APPLICATION NO.	CONT/PRIOR	CLASS	SUBCLASS	ART UNIT	EXAMINER
09/504344		365	104	2827	Chaw

Fixed burst memories

NOTICE OF DRAFTSPERSON'S
PATENT DRAWING REVIEW

FIG.2

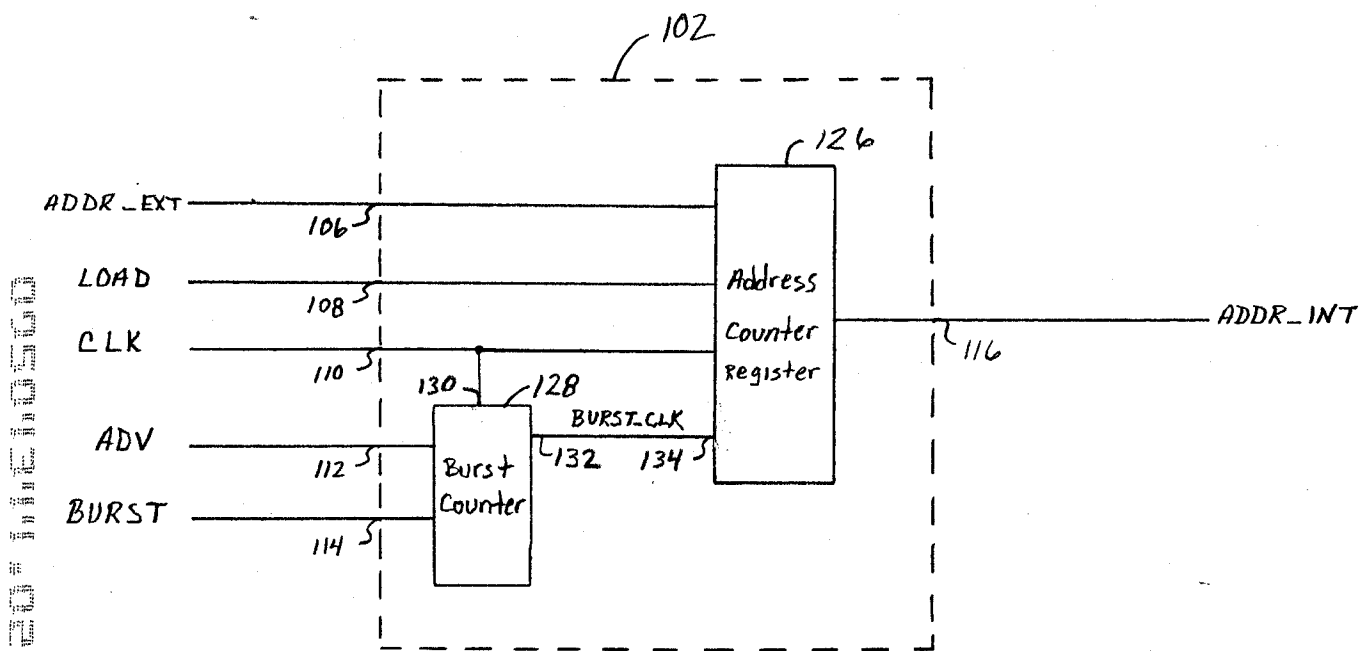
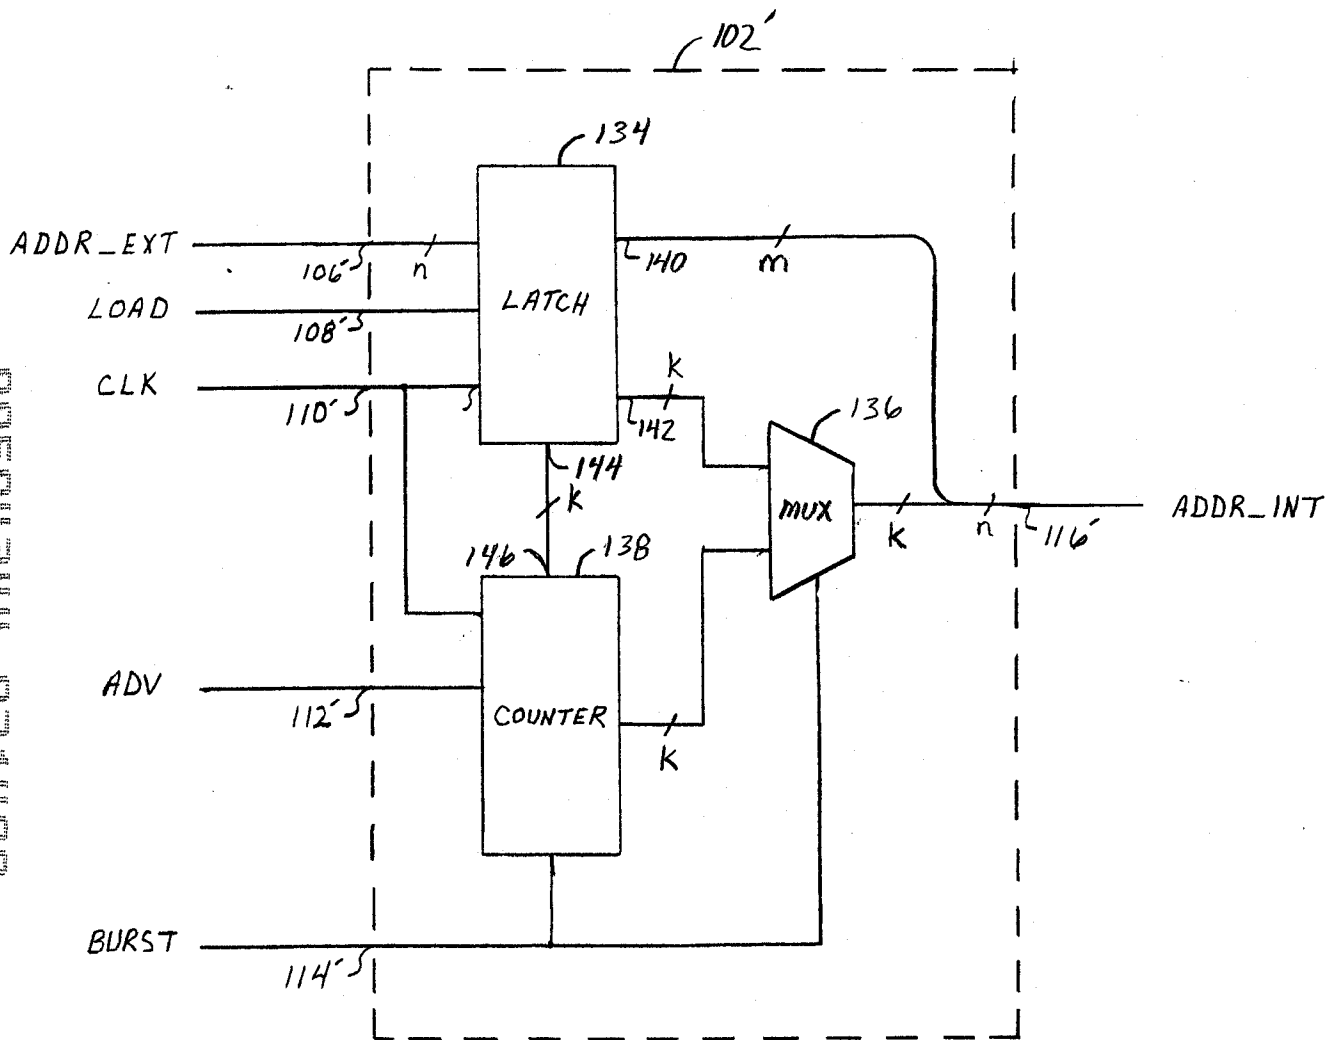
Top 2.5 cm Left 2.5cm Right 1.5 cm Bottom 1.0 cm
   SIZE: A4 Size
   Top 2.5 cm Left 2.5 cm Right 1.5 cm Bottom 1.0 cm
   SIZE: 8 1/2 x 11
   Margins not acceptable. Fig(s) 2,3,5A
   _____ Top (T) _____ Left (L)
   _____ Right (R) _____ Bottom (B)
6. VIEWS. 37 CFR 1.84(h)
   REMINDER: Specification may require revision to correspond to drawing changes.
   Partial views. 37 CFR 1.84(h)(2)
   _____ Brackets needed to show figure as one entity.
   Fig(s) _____
   _____ Views not labeled separately or properly.
   Fig(s) _____
   _____ Enlarged view not labeled separetely or properly.
   Fig(s) _____
7. SECTIONAL VIEWS. 37 CFR 1.84 (h)(3)
   _____ Hatching not indicated for sectional portions of an object.
   Fig(s) _____
   _____ Sectional designation should be noted with Arabic or Roman numbers. Fig(s) _____

New corrected drawings must be filed with the changes incorporated therein. Identifying indicia, if provided, should include the title of the invention, inventor's name, and application number, or docket number (if any) if an application number has not been assigned to the application. If this information is provided, it must be placed on the front of each sheet and centered within the top margin. If corrected drawings are required in a Notice of Allowability (PTOL-37), the new drawings MUST be filed within the THREE MONTH shortened statutory period set for reply in the Notice of Allowability. Extensions of time may NOT be obtained under the provisions of 37 CFR 1.136(a) or (b) for filing the corrected drawings after the mailing of a Notice of Allowability. The drawings should be filed as a separate paper with a transmittal letter addressed to the Official Draftsperson.
